REMARKS

Date: 6 AUGUST 2003

Fig. 13a

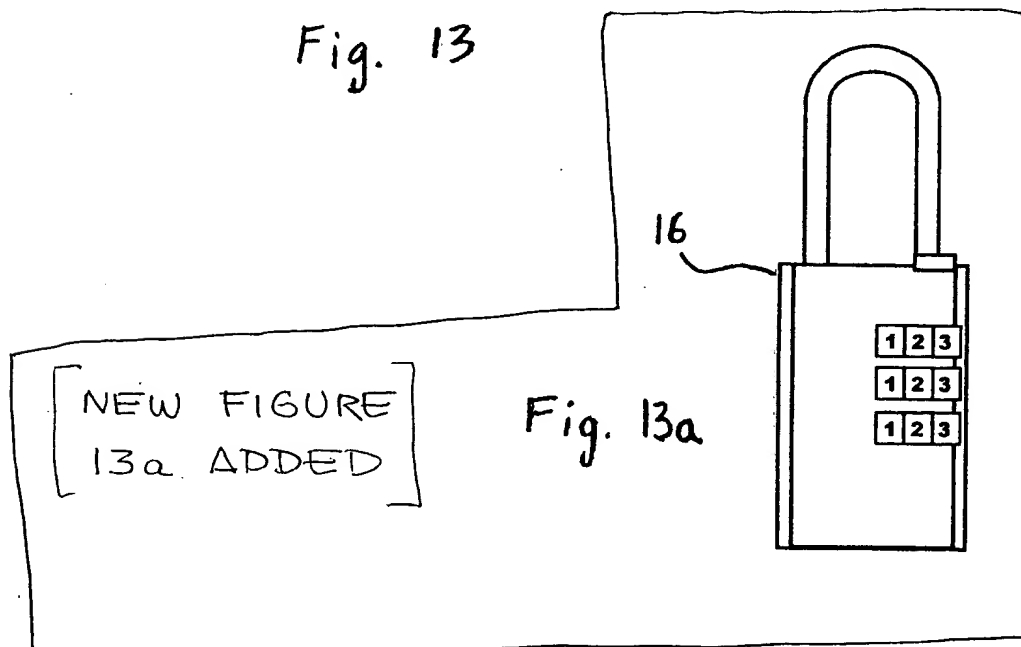
The Examiner has objected to the drawings under 37 C.F.R. § 1.83(a) on the grounds that the submitted drawings did not show every feature of the invention specified in the claims. Corrected drawings are included herewith which show the means to lock the hasp bar having a code-operated combination locking mechanism. In particular, the corrected drawings include a new figure, Fig. 13a.

[NEW FIGURE
13a ADDED]
